# AGENDA

## ARCHITECTURAL REVIEW BOARD MEETING

MARCH 12, 2024 IN THE CITY COUNCIL CONFERENCE ROOM AT 5:00 PM

**TO:** Planning and Zoning Commission  
**DATE:** March 12, 2024  
**APPLICANT:** Dub Douphrate; *Douphrate & Associates, Inc.*  
**CASE NUMBER:** SP2024-003; *Site Plan for a Two (2) Metal Buildings at 196 & 216 Ranch Trail*

DRAWING NAME:  
**ELEVATIONS- BLDG 'A'**

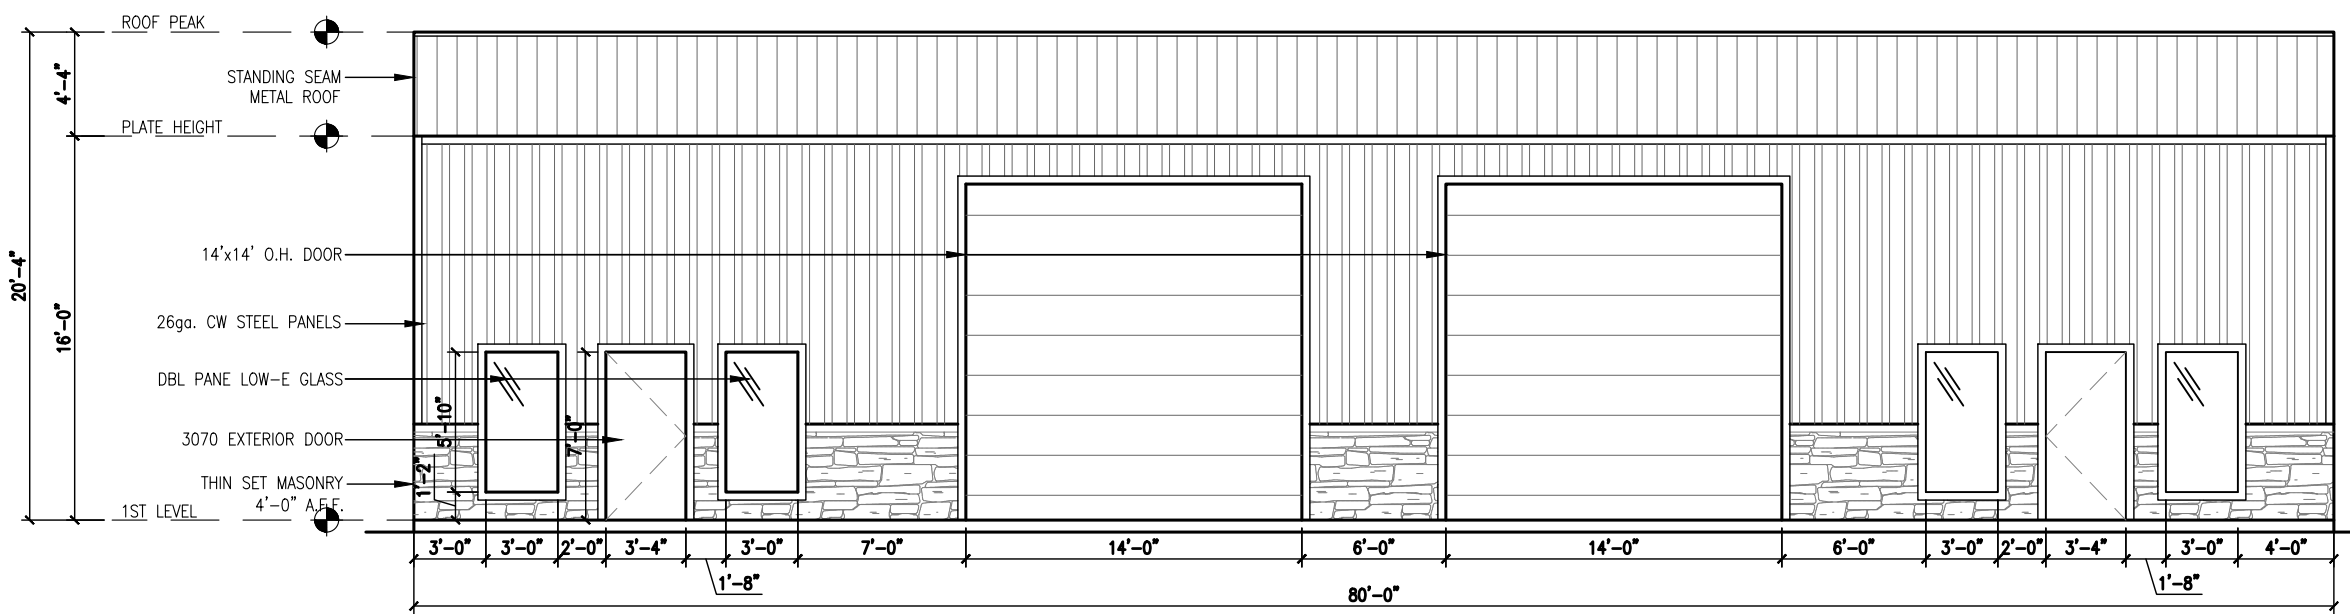
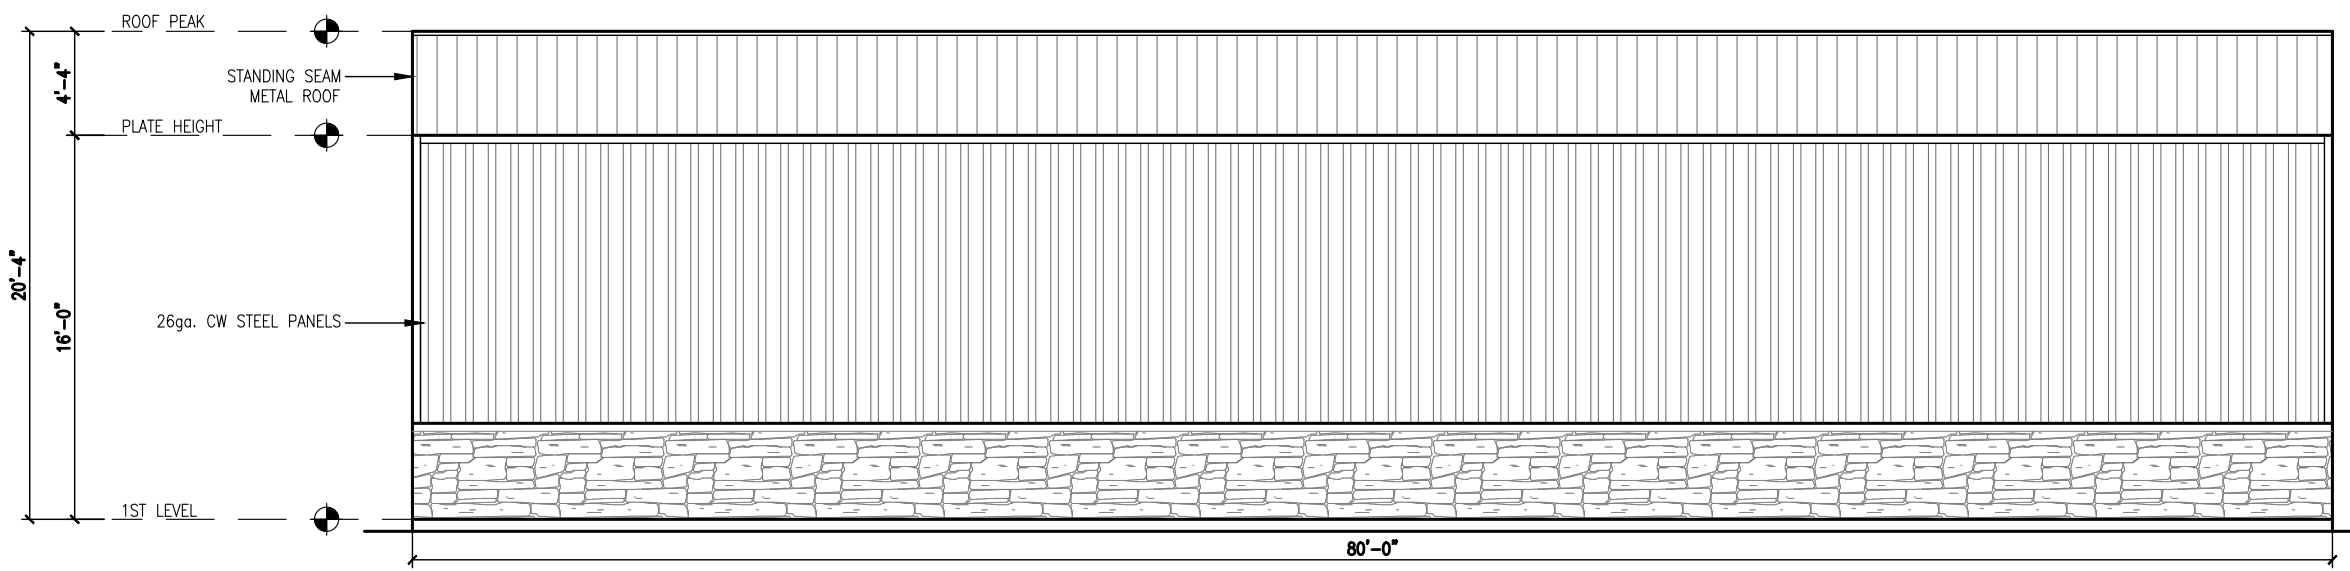
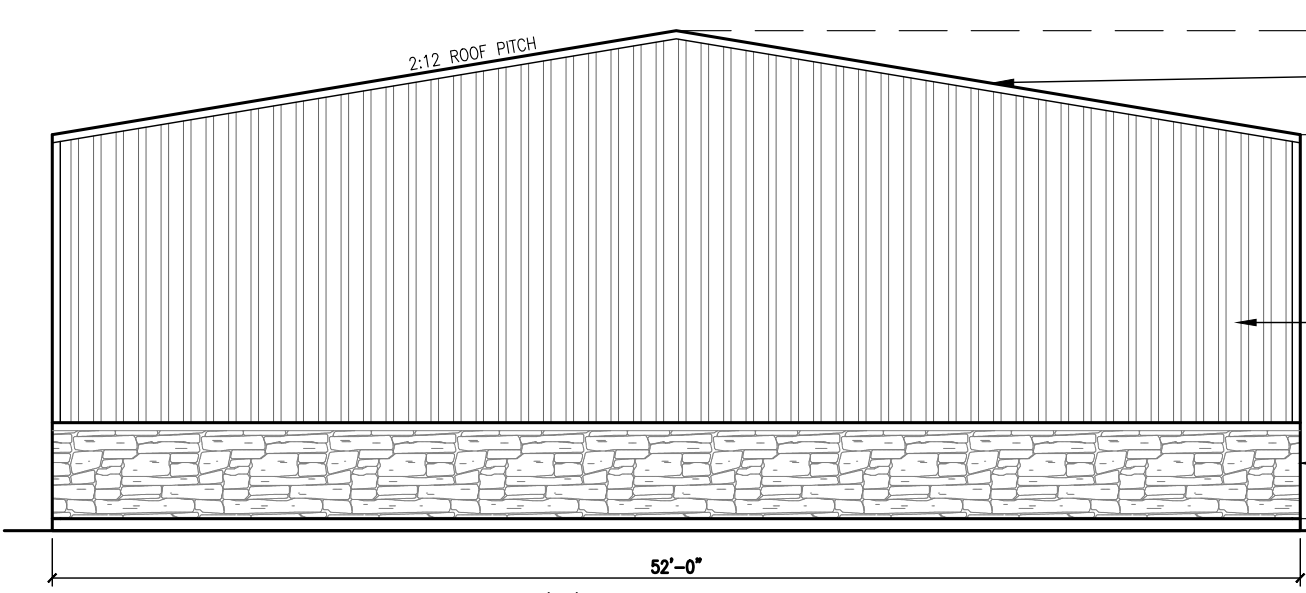
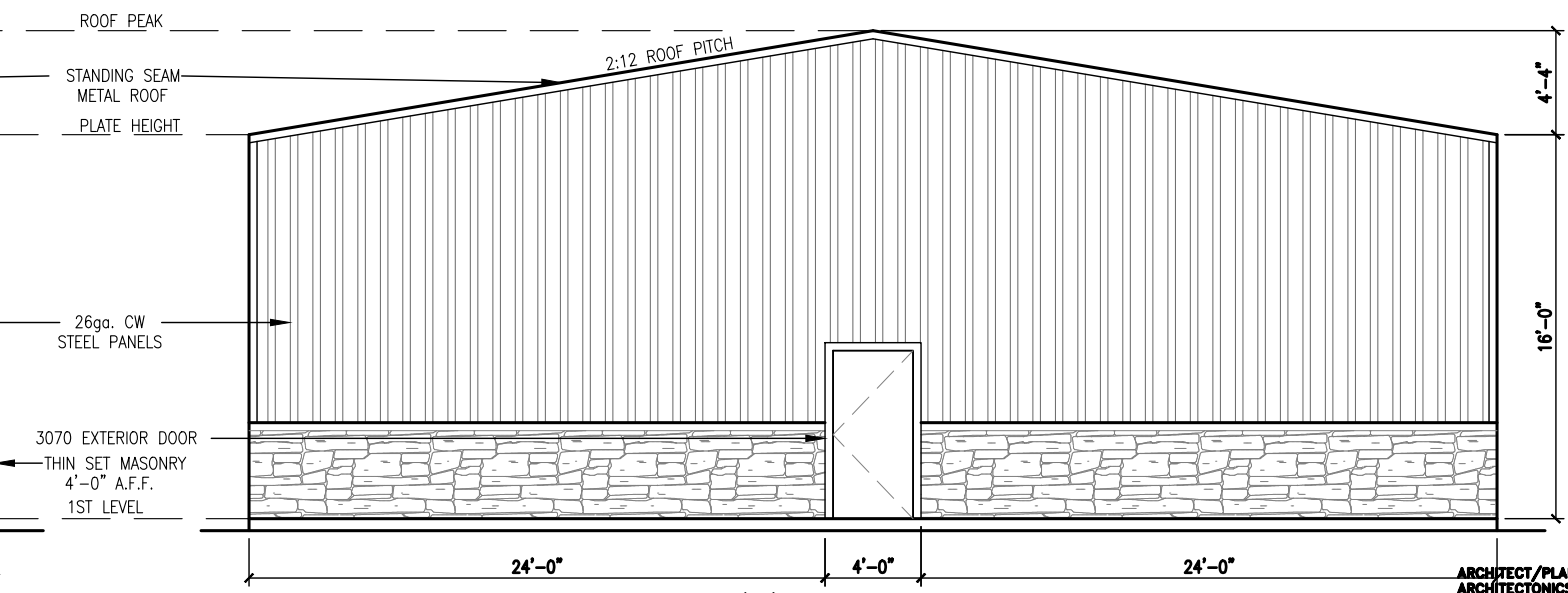
- (a) Roof Design Standards. According to Subsection 04.01 (A)(1) of Article 05, *District Development Standards*, of the Unified Development Code (UDC), "...all structures shall have the option of being constructed with either a pitched (*minimum of a 6:12 roof pitch*), parapet, or mansard roof system..." In this case, the proposed roof pitches on both buildings is 2:12. This will require the approval of an Exception from the Planning and Zoning Commission.

- (b) Building Articulation. Subsection 04.01(C) of Article 05, *District Development Standards*, of the Unified Development Code (UDC) details the building articulation requirements. Currently, the proposed building does not meet the primary and secondary building facades. Specifically, the proposed buildings do not meet the projection standards of the UDC. This will require the approval of an Exception from the Planning and Zoning Commission.

The Architectural Review Board (ARB) reviewed the building elevations provided by the applicant on February 27, 2024. The ARB recommended that the applicant provide a wainscot on the existing buildings in order to match the proposed buildings' appearance. Before action is taken on the elevations, the ARB wants to see the revised elevations at the March 12, 2024 meeting.

**EXTERIOR ELEVATIONS**

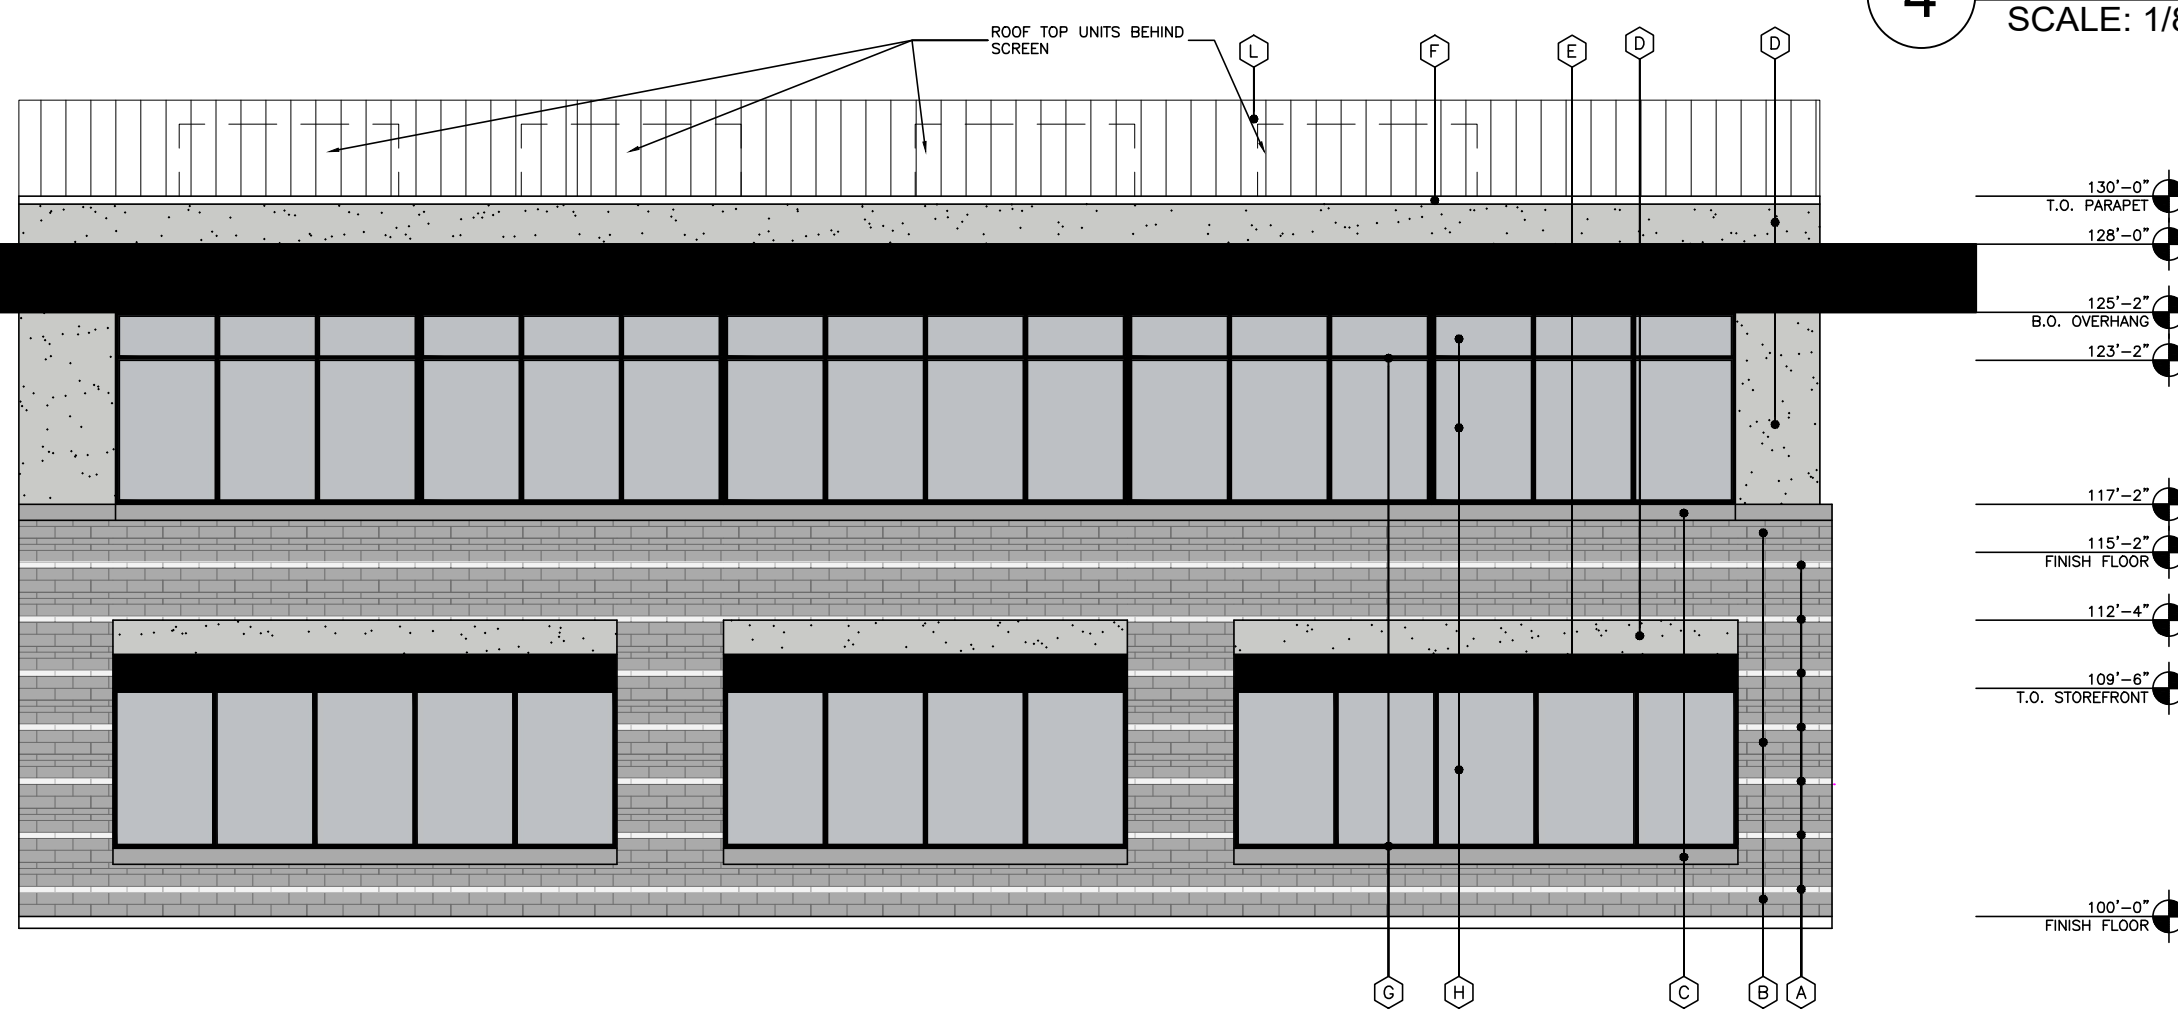
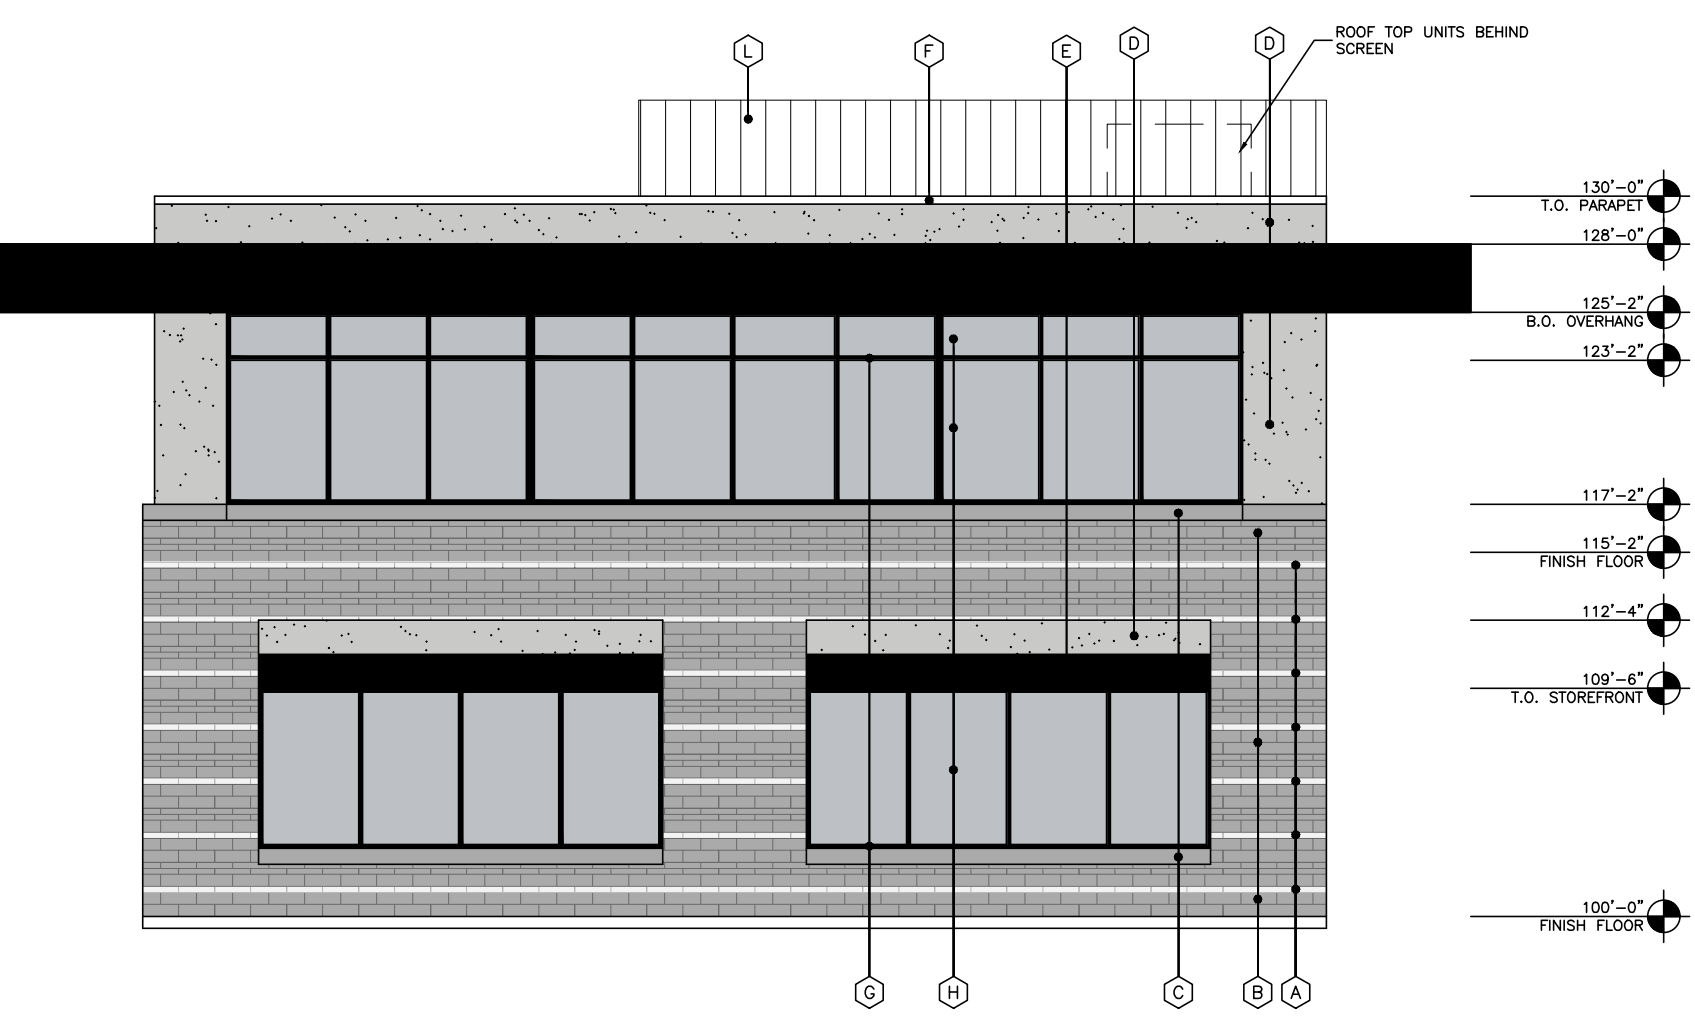
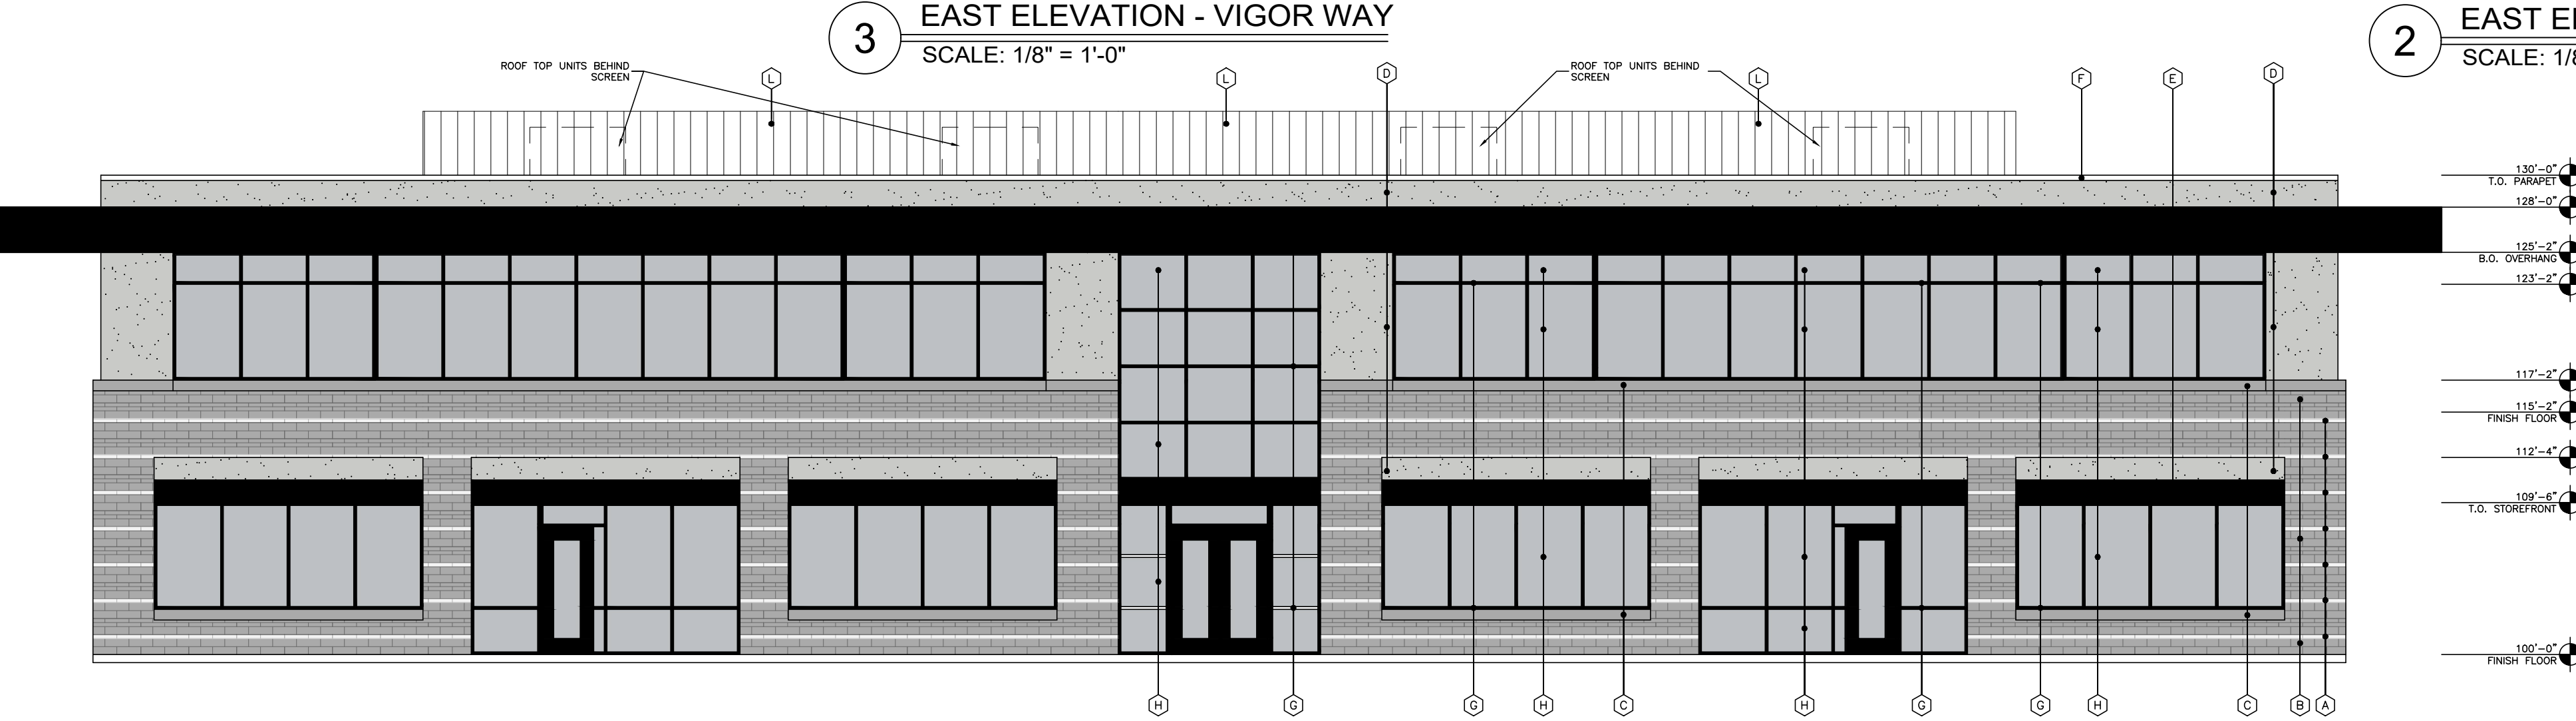
- (1) *Four (4) Sided Architecture*. According to Article 05, *General Overlay District Standards*, of the Unified Development Code (UDC), "(a)ll buildings shall be architecturally finished on all four (4) sides utilizing the same materials, detailing, articulation and features. In addition, a minimum of one (1) row of trees (*i.e. four [4] or more accent or canopy trees*) shall be planted along perimeter of the subject property to the rear of the building." In this case, the building elevations do not meet the articulation standards and are not finished with the same finishes and details on all four (4) facades of the building. In addition, the applicant has not provided a row of trees along the perimeter of the subject property to the rear of the building. This will require a *Variance* from the Planning and Zoning Commission.

- (2) *Primary Articulation*. According to Article 05, *General Industrial Commercial Standards*, of the Unified Development Code (UDC), "(a) primary building façade is any building façade that has a primary entryway for a business or that has an adjacency to a public right-of-way, open space/green space, public/private park, and/or a residential zoning district or residentially used property. All commercial buildings shall meet the standards for articulation on primary building façades as depicted in *Figure 7*." In this case, the building elevations do not meet the standards for articulation on all the primary facades, specifically the projection and wall length requirements. This will require a *Exception* from the Planning and Zoning Commission.

On February 27, 2024 the Architecture Review Board reviewed the building elevations provided by the applicant and requested the applicant provide colored elevations and renderings. The applicant has provided colored elevations. These will be reviewed by the ARB at the March 12, 2024 meeting for a recommendation to the Planning and Zoning Commission.
